35 Kangaroo Street Manly 2095 NSW Re: Amended Development Application Drawing DA2021/2146

I enclose amended drawings 01-06 Dated 29 April 2022 Issue B.

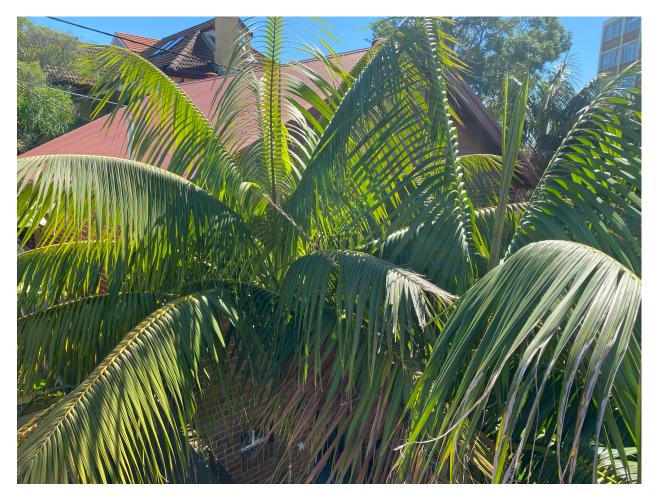
I also enclose photographs taken from the existing west facing first floor flat roof area taken near the western edge of the roof area looking south overlooking 33 Kangaroo Street and looking north overlooking 37 Kangaroo Street.

It should be noted that the proposed louvre screening will now preserve the privacy of the private open space and deck area of 33 Kangaroo Street and also the open lawn area of 37 Kangaroo Street with the length and height of the proposed angled louvre screens preventing any overlooking of these areas.

The photograph taken to the north overlooking 37 Kangaroo Street shows that the existing mature palm trees planted close to the south boundary of 37 Kangaroo Street largely obscure any direct views from the open first floor roof area at the present time.
